State of Alaska
Department of Environmental Conservation
Village Safe Water Program

Re: Amendment 3
RFP 22-VSW-WAA-005
Construction of Water Treatment Plant and Washeteria
Wales, Alaska
RFP Due Date: November 17, 2021 @ 2:00 PM AST

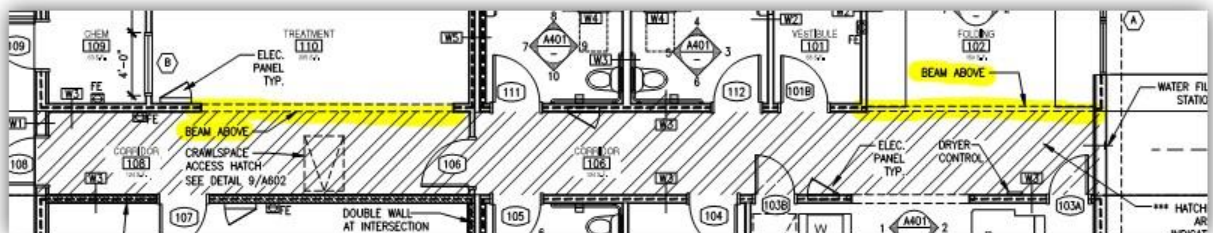
4. **Vendor:** We have received indication from numerous vendors that seem to be a bit confused on the documents; specifically with understanding what work is to be in the project since there are items crossed off on the drawings. I believe this had to do with trying to differentiate between the Base bid

and the Alternate work. It would be helpful if you could add some clarification in the upcoming addenda on the intent.

Department: The work crossed off in the Base Bid Drawing Set “City of Wales Water Treatment Plant and Washeteria Improvements Project December 2019” were redesigned and superseded by the Alternate Work Drawing Set “Wales, Alaska Heat Recovery System June 2020”. The item crossed out of the base bid set are not to be constructed. Please note the heat recovery lines shown on the C104 of base bid (Points 24-32) are not included with the base bid and have been replaced with sheet C102 of the alternate work. Please email the procurement officer to request these drawings. Due to file size these will be sent to the requestor via [Zend To](#).

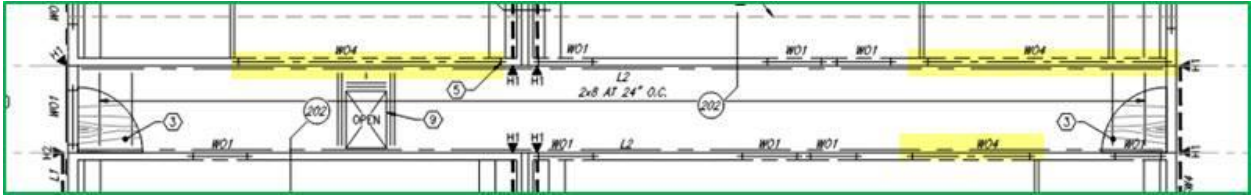
7. **Vendor:** Addenda #2 Q/A 19. Sheet A101 makes reference to “Beam Above” at Room 110 and Room 102 (on Grid B). Structural detail 205 (called out on S104 & S105) sheet S502 does not indicate the beam. Please clarify. Department responded: Beams are indicated on S103. Sheet S103 is “floor framing Plan”. Question above was reference to what appears to be a beam (header?) required at these open span areas, on A101. These are not shown on structural drawings.

Department: The response to amendment 2 question & answer # 19 is correct. These headers are shown on S103. See S007 for wall opening schedule.
